Contract No. T201330009.01
Federal Aid Project No. ESTP-N061(01)
Industrial Track Greenway Phase III
New Castle County

Enclosed is Addendum No. 3 for the referenced contract consisting of the following:

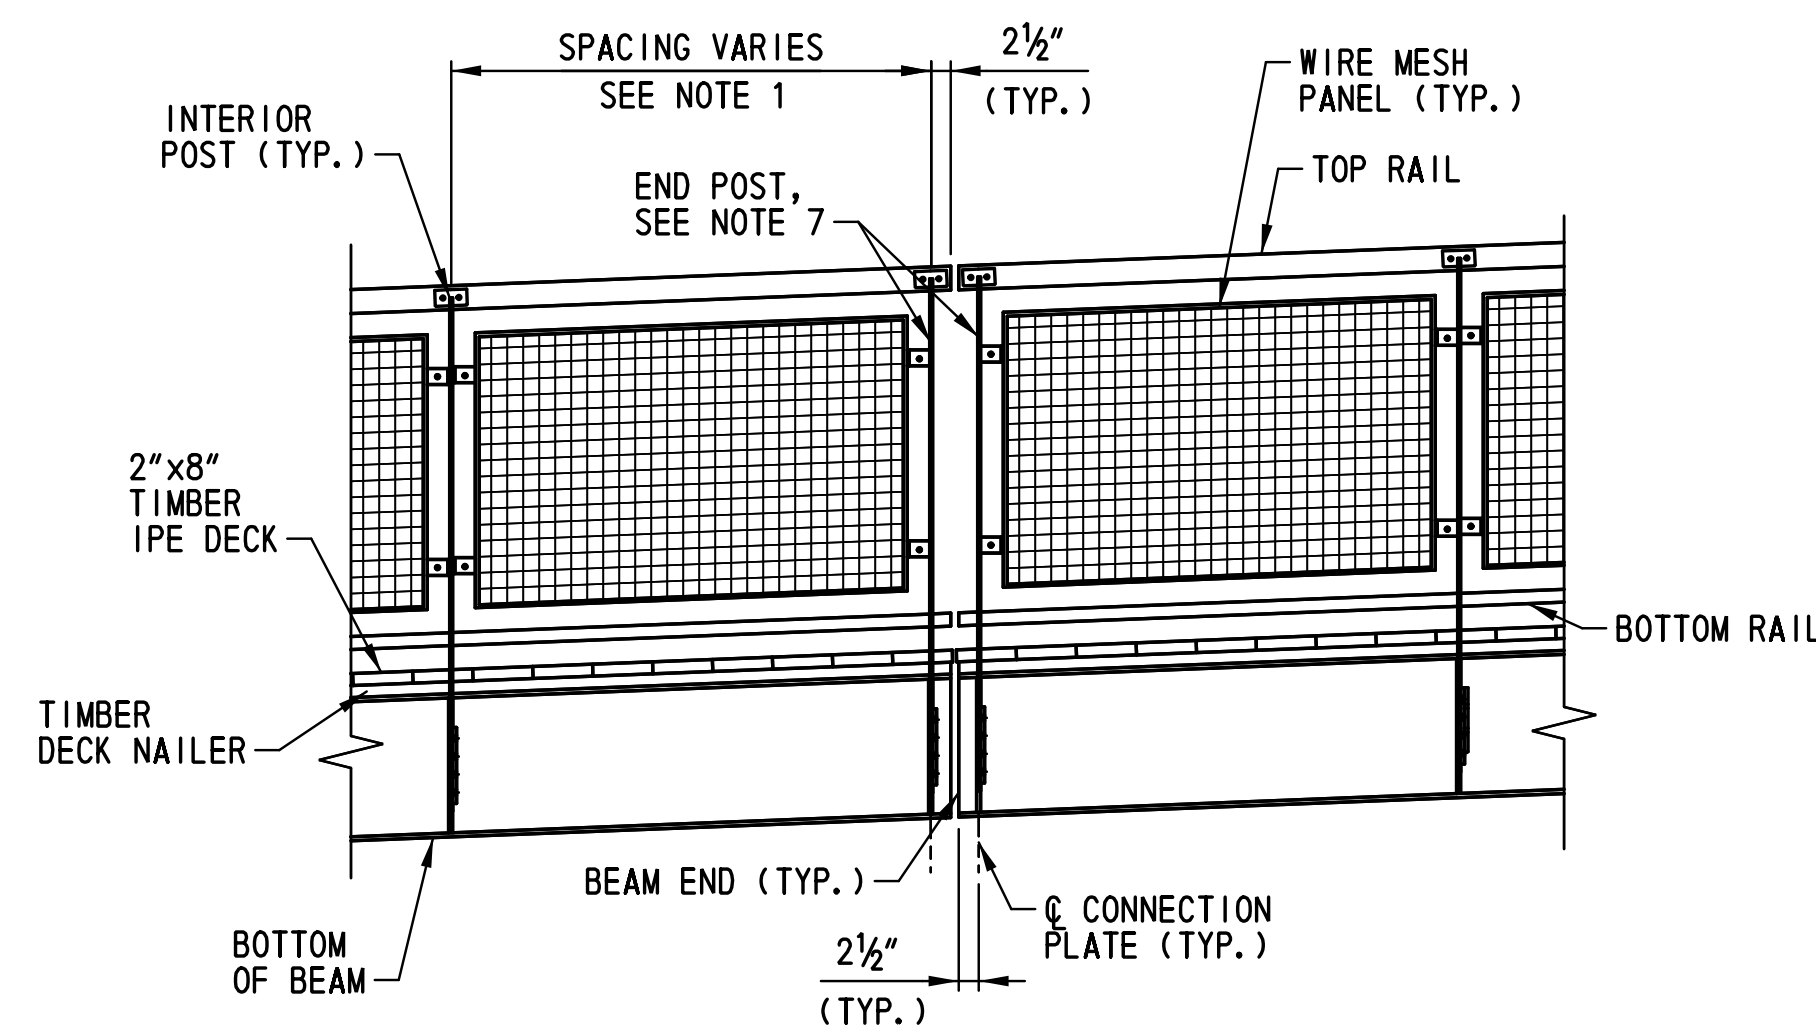
ADDENDUMS / REVISIONS		SCALE: NONE	NEW CASTLE INDUSTRIAL TRACK TRAIL, PHASE 3	CONTRACT	BRIDGE NO.	X	PROJECT NOTES CHRISTINA RIVER CROSSING	SHEET NO.
	△ REVISED PROJECT NOTE 4: D.D./J.N. 02/16/16 △ REVISED PROJECT NOTE 11: A.D./J.N. 03/02/16				T201330009				39
					COUNTY	DESIGNED BY: NAH			TOTAL SHTS.
					NEW CASTLE	CHECKED BY: WAG			207

RL-301
SHEET NO.
160
TOTAL SHTS.
207

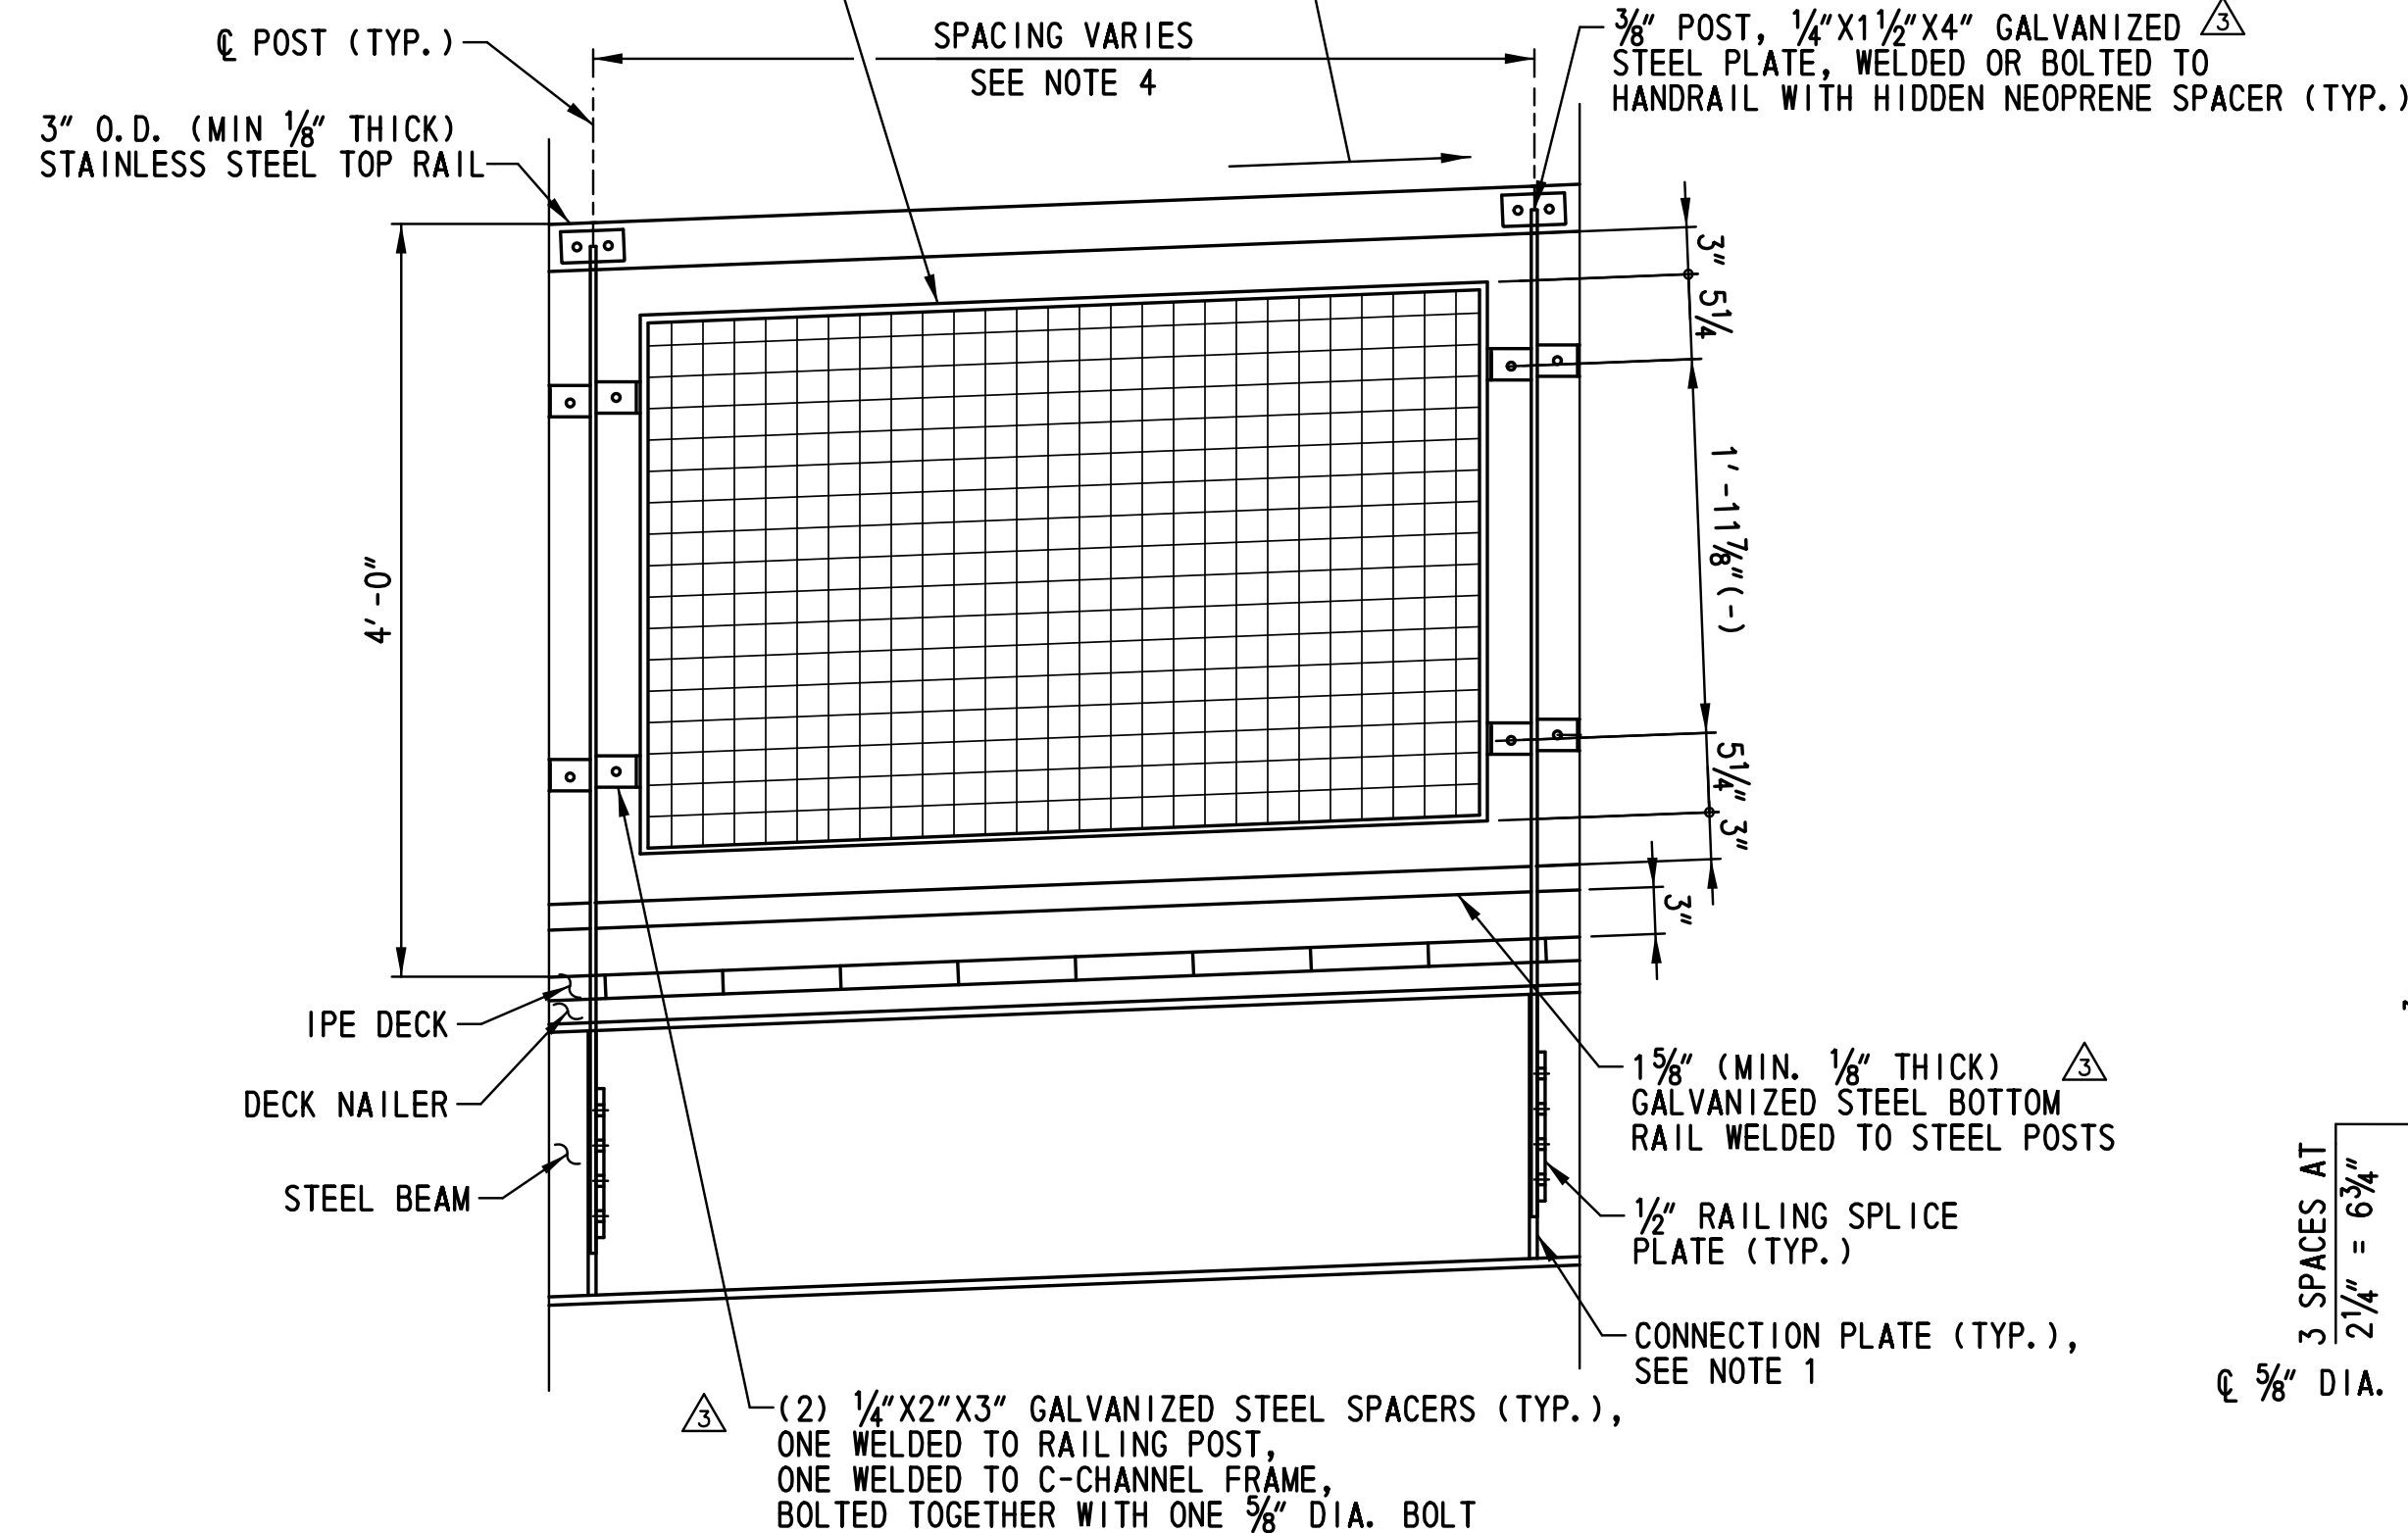
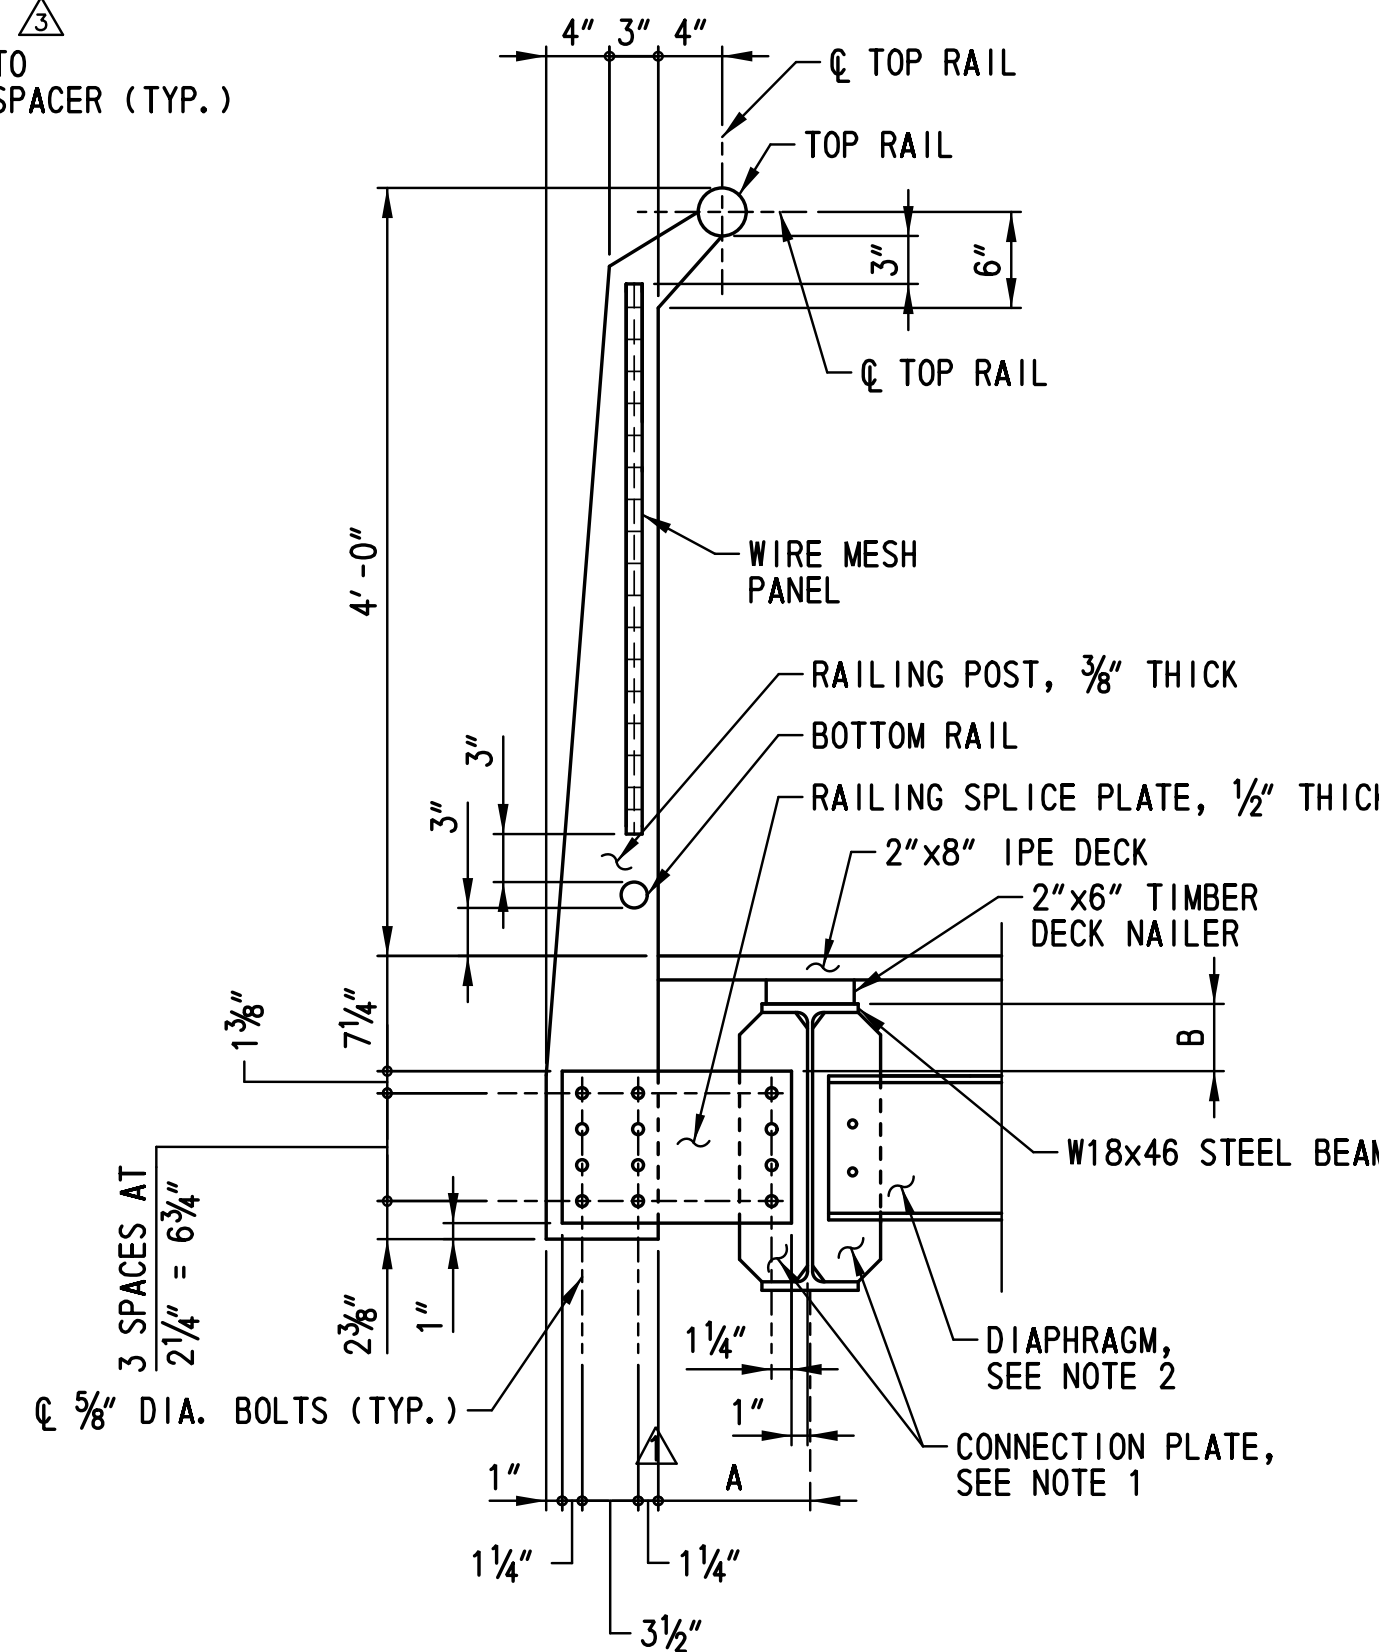
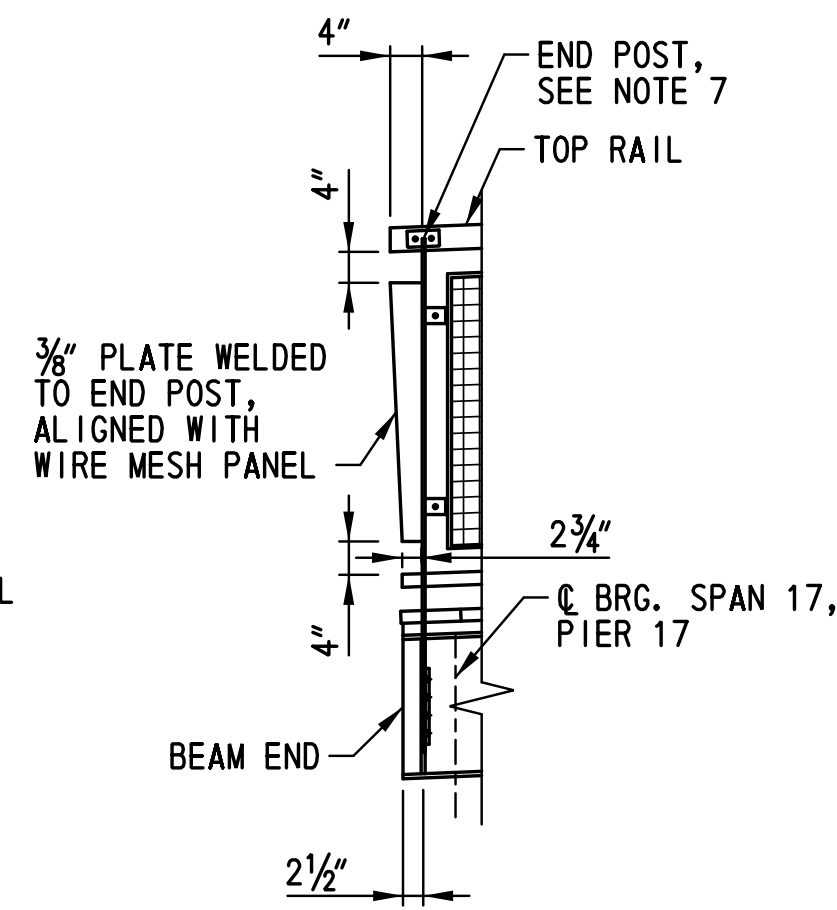
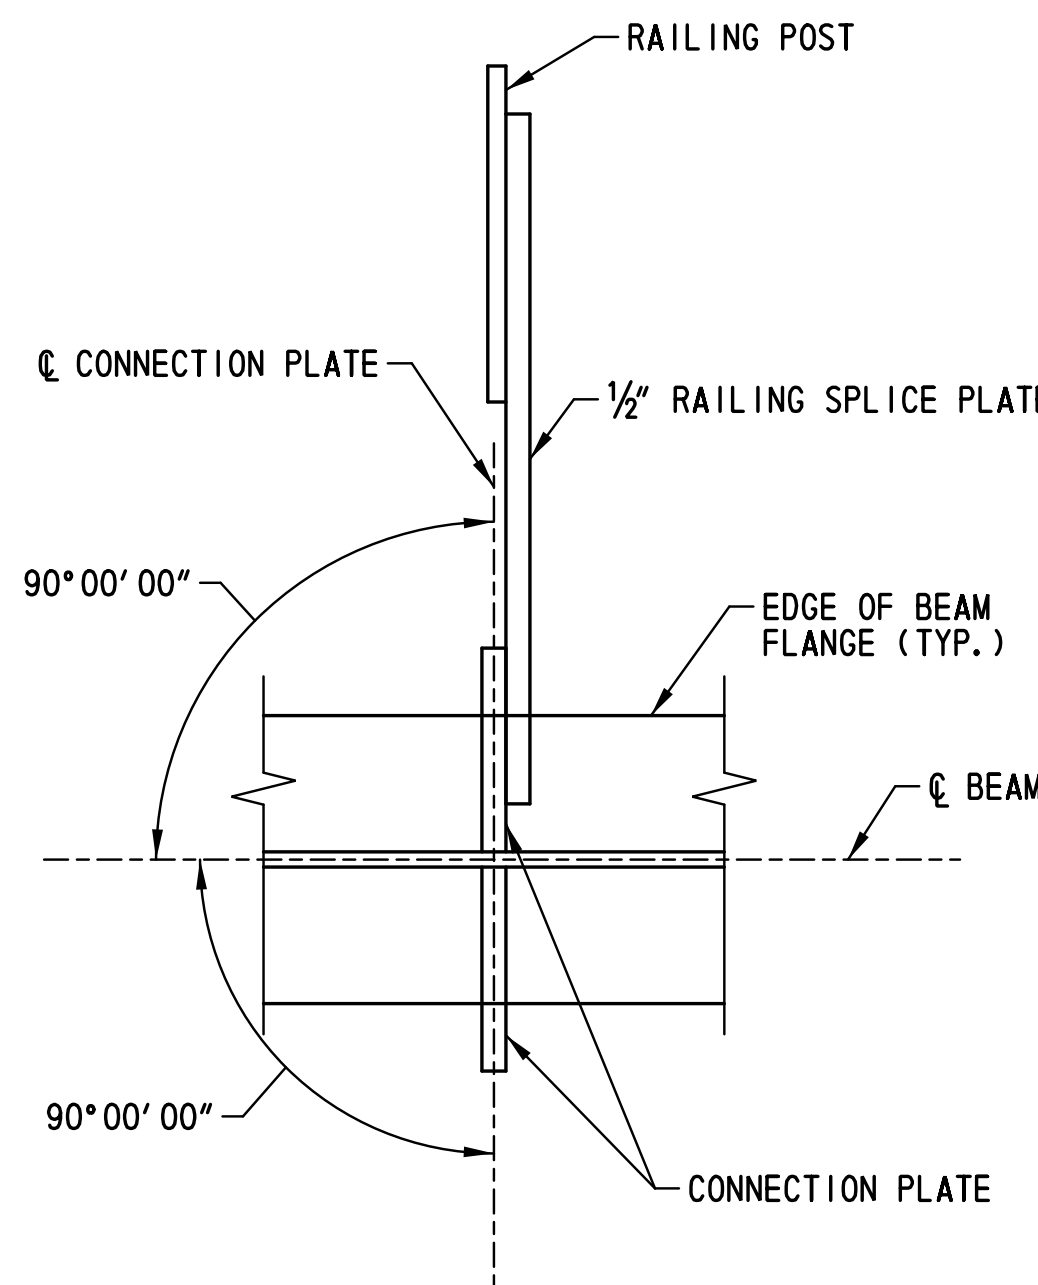
△ GALVANIZED STEEL WIRE MESH PANEL:
NO. 8 GAUGE, 1 1/2" WOVEN WIRE
MESH CINCHED AND CENTERED TO 1" X 1/2" X 1/8"
C-CHANNEL FRAME, PREFABRICATED (TYP.)

ADDENDUMS / REVISIONS	
△	REV. DETAIL NOTE: A.D./J.N. 03/02/16
	REV. SHEET NOTES: A.D./J.N. 03/02/16

- ALL BOLTS SHALL BE 5/8" DIA. STAINLESS STEEL CONFORMING TO ASTM A193 B8 CLASS 2. ALL HOLES SHALL BE 1/8" DIA. MISCELLANEOUS FASTENERS USED FOR SPACER AND RAILING CONNECTIONS SHALL BE TYPE 304 STAINLESS STEEL.

- RAILING POST AND PLATE MATERIALS SHALL BE ASTM A36 STEEL OR APPROVED EQUAL AND GALVANIZED IN ACCORDANCE WITH ASTM 123. ALL STAINLESS STEEL TUBE SHALL BE TYPE 304 STAINLESS STEEL, CONFORMING TO ASTM A269 OR APPROVED EQUAL. WOVEN WIRE MESH INFILL PANELS SHALL CONSIST OF NO. 8 GAUGE WIRE MATERIAL MEETING THE REQUIREMENTS OF ASTM A 853 AND GALVANIZED IN ACCORDANCE WITH A 123.
